# EASTERN CORRIDOR SEGMENTS II AND III (PID 86462) US 50 CORRIDOR FOCUS AREA ADVISORY COMMITTEE MEETING NOTES

## Meeting Dates

Figure I-13D

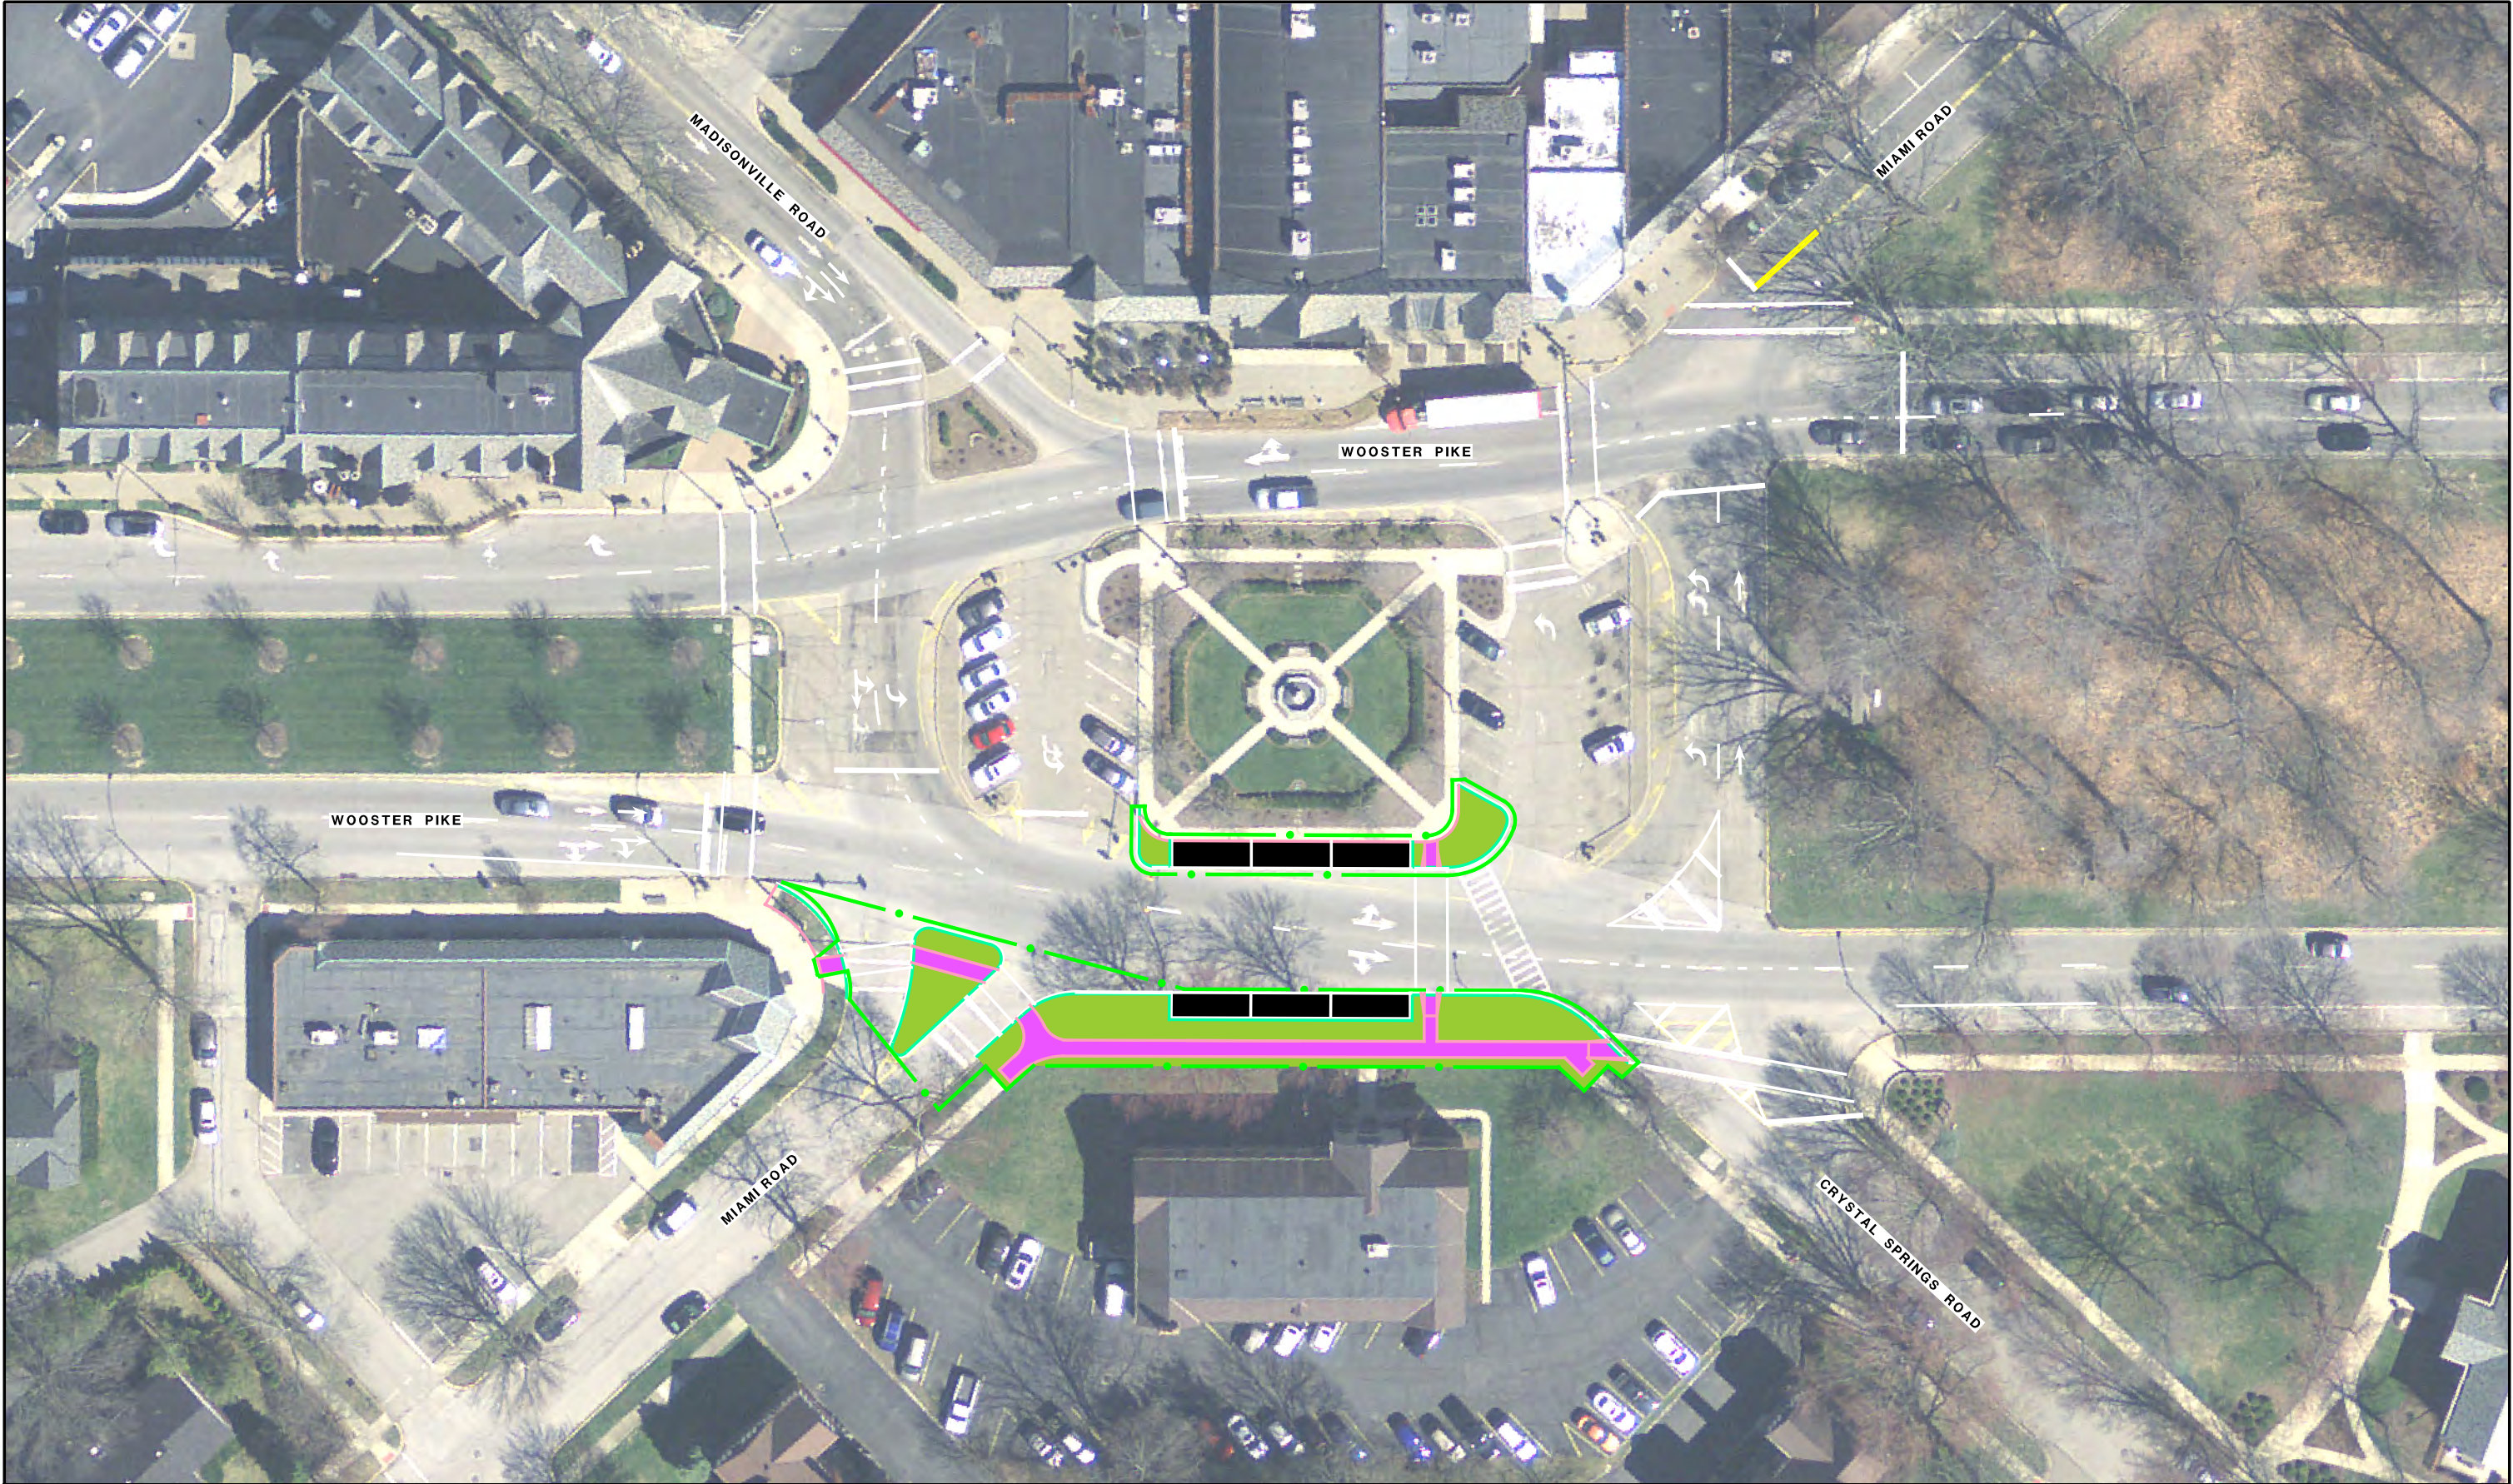
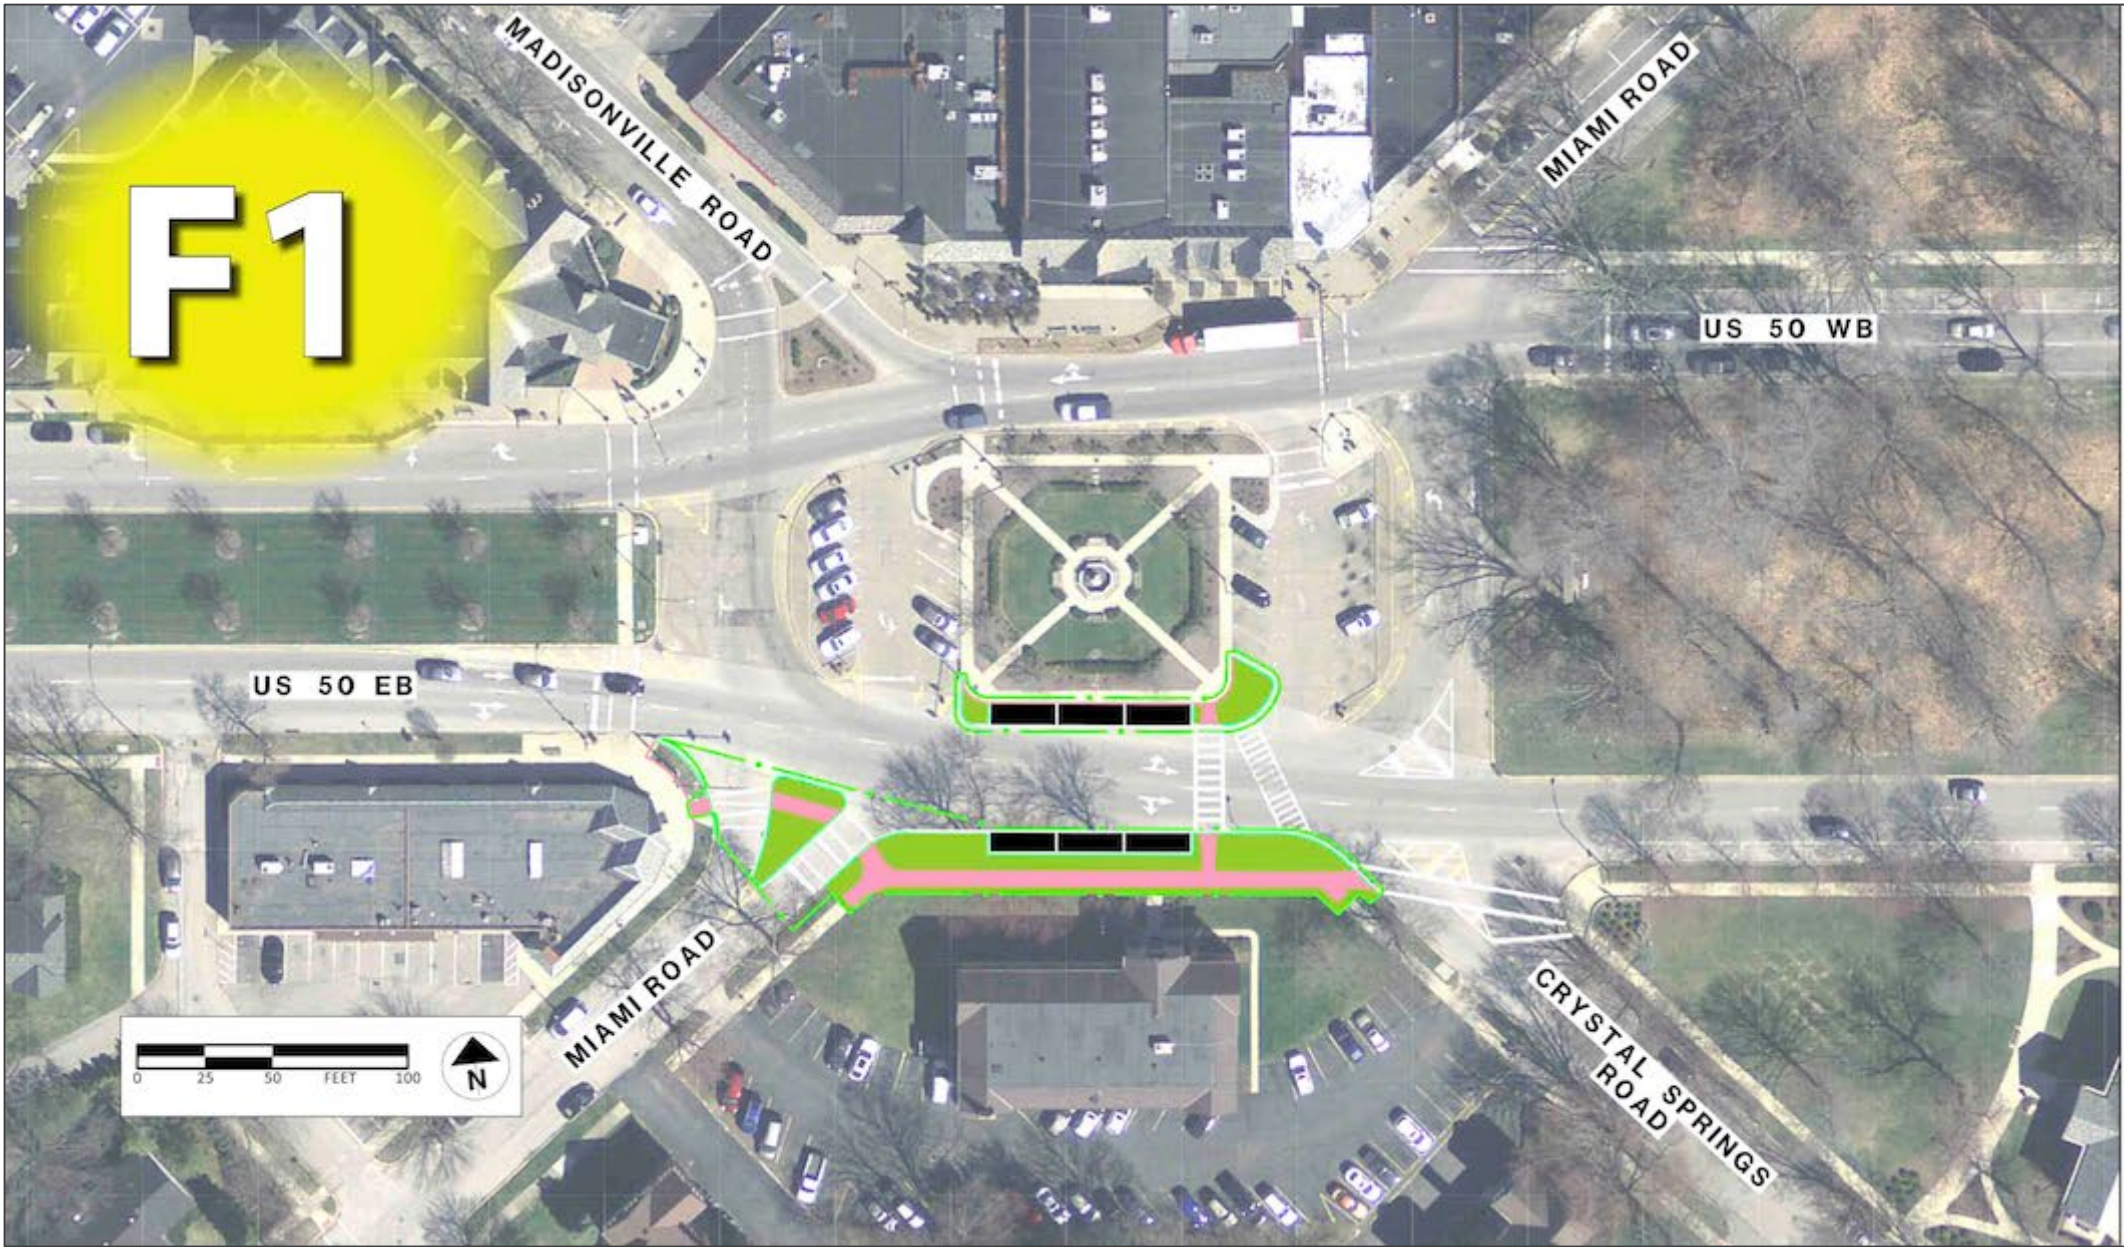
- This concept is intended to address a sight deficiency for drivers traveling northbound on Miami Road and turning right onto Wooster/US 50 (south side of Mariemont Square). This movement is currently not signalized.
- A curb bump would be added, moving the stop bar (line in the road) forward so that drivers are better able to see past the existing building on their right.
- The concept has the additional potential benefit of straightening the existing crosswalk. This would be particularly helpful for pedestrians.
- The four existing parking spaces would be preserved.
- Pavement removed in this concept could be replaced with grass. Existing trees would be saved.
- A new raised island could be established on Miami Road, similar to the island on Plainfield Road on the north side of the Square

- Mariemont will provide sketch outlining design options. Limited time being allowed to submit comments did not allow Mariemont to submit sketch at this time. Continued dialogue is needed to address safety, parking, and aesthetics.

- Include project in Implementation Plan as a low priority. It will be up to the Village of Mariemont to choose between concepts I-13d (F1) and I-13e (F2) and decide whether or not to implement the project.
- Consider advancing the sidewalk relocation component as a separate, higher priority project.
